## 211143 Mounting Brackets

Figure 1

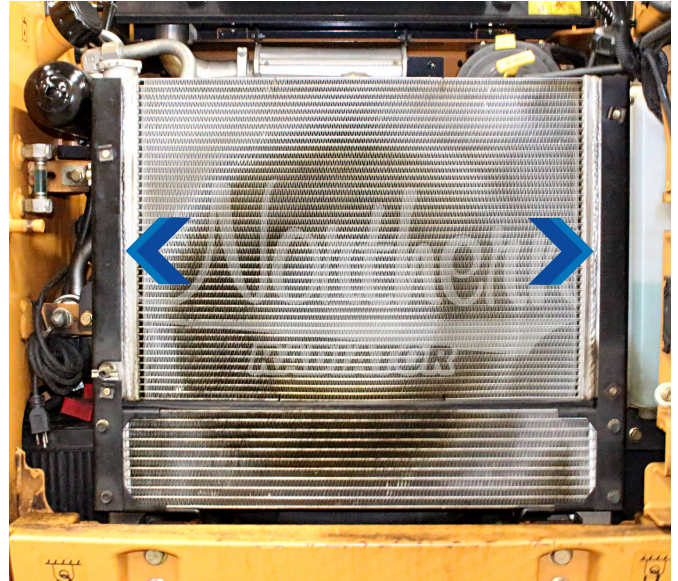
For applications with old design full length brackets (**Figure 1**) please use the provided brackets (**Figure 2**) in the box when installing Northern's 211143 radiator. Due to eliminating the full length side bracket, the upper radiator mounts will now mount directly to the new radiator (**Figure 4**).

Figure 3

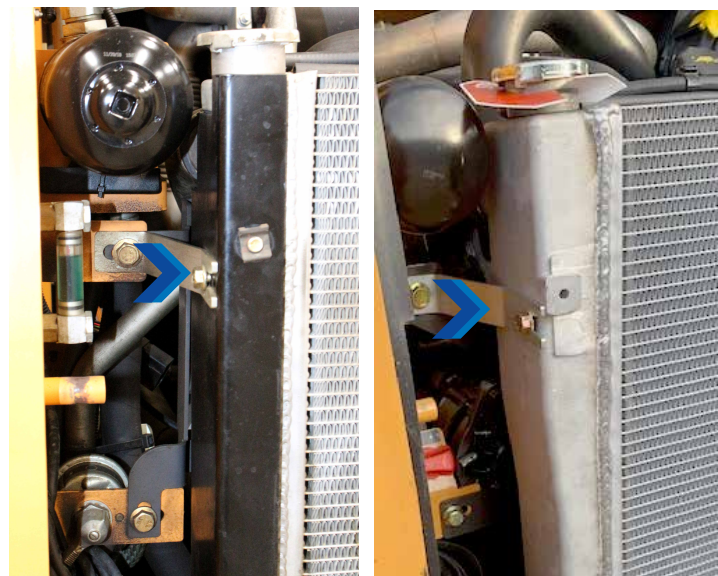
**Figure 3** illustrates the proper way to install the provided brackets. All other applications will reuse the original mounting.
